To: T10 Technical Committee
 From: Rob Elliott, HP (elliott@hp.com)
 Date: 4 July 2006
 Subject: 06-279r1 SAS-2 Allow more than one ZSDS in a SAS domain

Overview

Figure 1 — Two ZPSDSes introduction

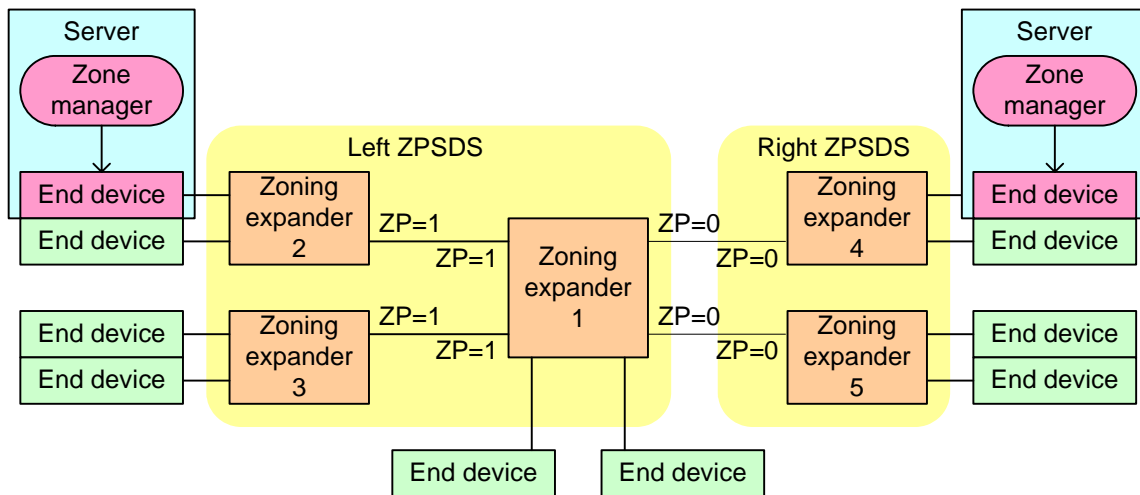
Figure 1 shows two ZPSDSes. As long as the ZONE PARTICIPATING bits are set to zero at the boundaries, they can coexist - devices on the left would not be able to talk to devices on the right (but all the devices can all see all the expanders, since expanders are in ZG 1).

Figure 4 — Three ZPSDSes example

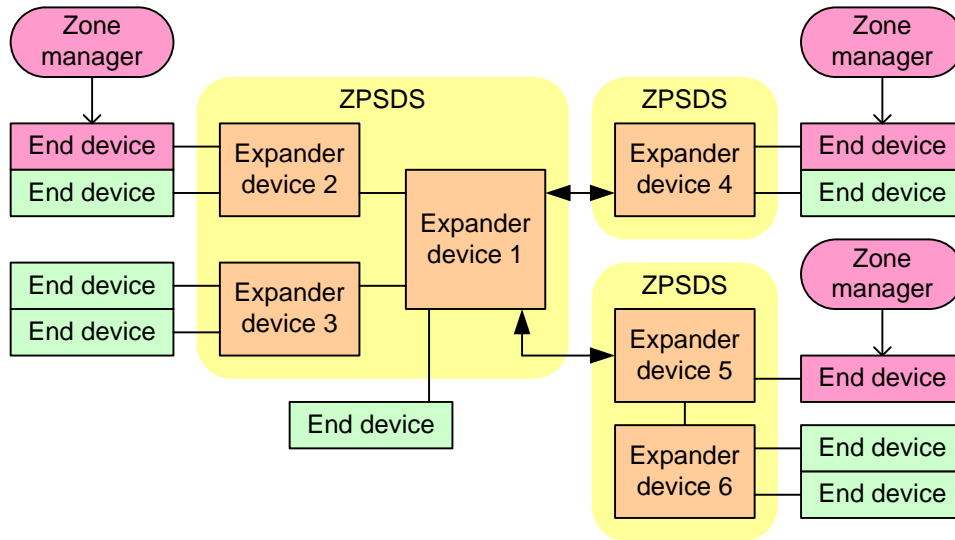
There shall be at most one may be any number of non-overlapping ZPSDSes in a service delivery subsystem, particularly as a SAS domain is being reconfigured (e.g., as a user is attaching enclosures together). The A ZPSDS may encompass some or all of the service delivery subsystem.

Figure 4 shows an example of three ZPSDSes in a SAS domain.

Figure 55 — Example of a ZPSDS with the ZONE ADDRESS RESOLVED bit set to zero updated to remove “Zoning” and “Non-zoning” prefixes in front of “expander device”

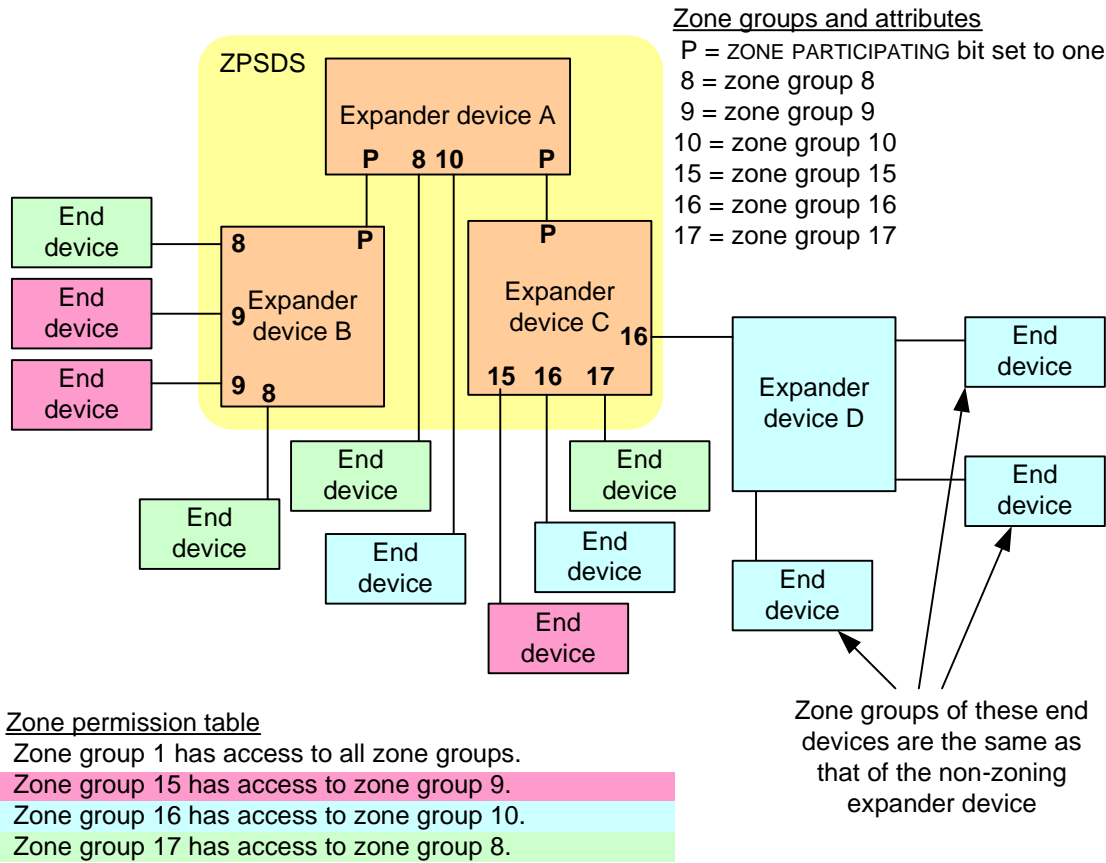
Editor's Note 3: the following text and figures were moved from 4.8.1.

Figure 55 shows an example of a ZPSDS in which the ZONE ADDRESS RESOLVED bit of the expander port of ~~zoning~~ expander device C that is attached to ~~non-zoning~~ expander device D is set to zero.

Figure 56 — Example of a ZPSDS with the ZONE ADDRESS RESOLVED bit set to one updated to remove “Zoning” and “Non-zoning” prefixes in front of “expander device”

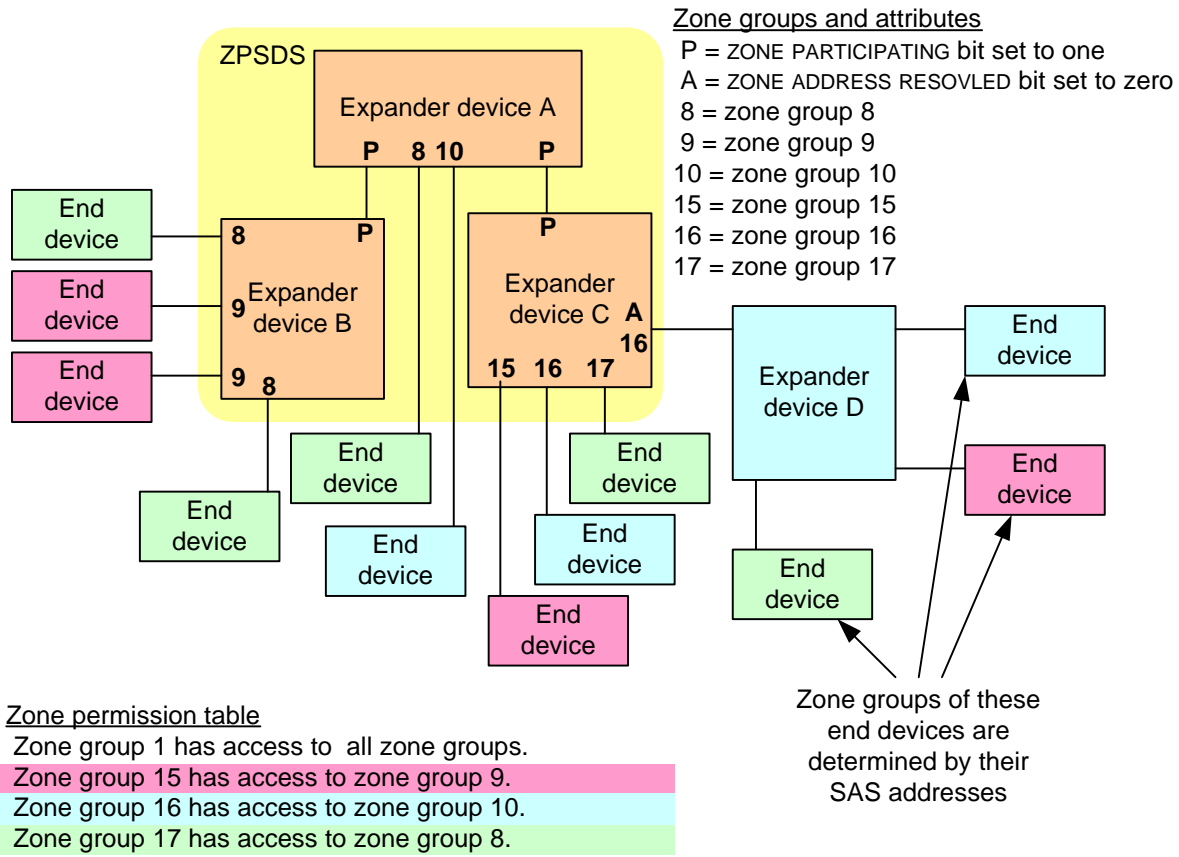
Figure 56 shows an example of a ZPSDS in which the ZONE ADDRESS RESOLVED bit of the expander port of ~~zoning~~ expander device C that is attached to ~~non-zoning~~ expander device D is set to one.
